Subject : Transmittal of Revision 2 to Service Bulletin No. V2500-ENG-72-0294

## ENGINE - LP TURBINE ASSEMBLY - DUCT SEGMENT INNER - REMOVAL SHEETMETAL FIN

72-50-00

## ENGINE - LP TURBINE - DUCT SEGMENT INNER - REMOVAL OF SHEET METAL RIM

LPT Inner Diffuser duct – marking position  
Figure 1

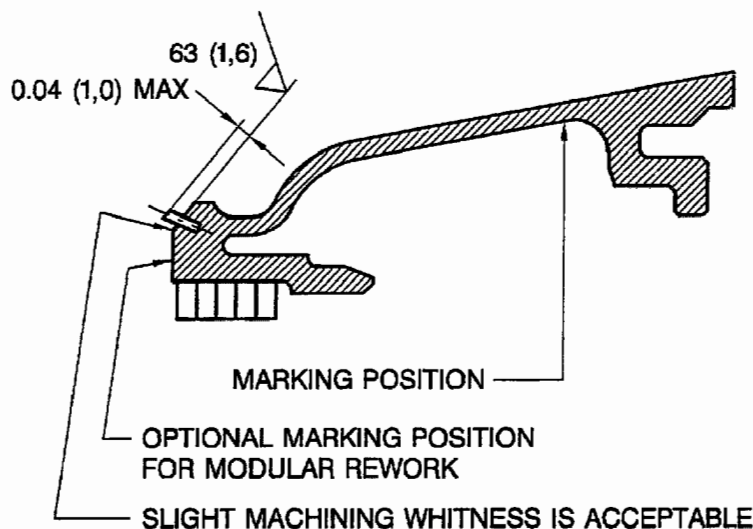
- (1) Protect the LPT transition duct and the spline and thread at the front end of the shaft.  
Use local manufactured cover or tape.
- (2) Machine off the Sheet Metal Rim Seal
  - (a) Use Pneumatic Hand Held Grinder and Rotary Files or equivalent. Refer to Fig 1.
  - (b) Break sharp edges
- (3) Re-identify the Inner Diffuser Ducts at the optional marking position. Refer to Fig 1.

- (1) Machine off the Sheet Metal Rim Seal
  - (a) Use Pneumatic Hand Held Grinder and Rotary Files or equivalent. Refer to Fig 1.
  - (b) Break sharp edges
- (2) Re-identify the Inner Diffuser Ducts at the marking position and cross out the old part number. Refer to Fig 1.

- THIS REWORK IS BASED ON APPROVED ENGINEERING CHANGE EC97VM022 AND CAN BE DONE ON PART NUMBER 3A0771 AS A PIECE PART OR IN MODULAR ASSEMBLED CONDITION.
- GRIND OFF SEAL LIP. 0.04 (1,0) MAX PROTRUSION PERMISSABLE AFTER REWORK.
- AFTER REWORK CHANGE PART NO. FROM 3A0771 TO 3A2493. USE THE MECHANICAL VIBROPEEN METHOD AS PER SPM-TASK 70-09-00.
- IF THE REWORK IS PERFORMED ON A SEGMENT ASSEMBLED TO THE MODULE THEN MARK THE PART AT THE OPTIONAL MARKING POSITION WITH 3A2493 AND THE SERVICE BULLETIN NO. V2500-ENG-72-0294. AT NEXT OPPORTUNITY OF ACCESS CROSS OUT THE OLD PART NO. 3A0771 AND REPLACE BY PART NO. 3A2493.
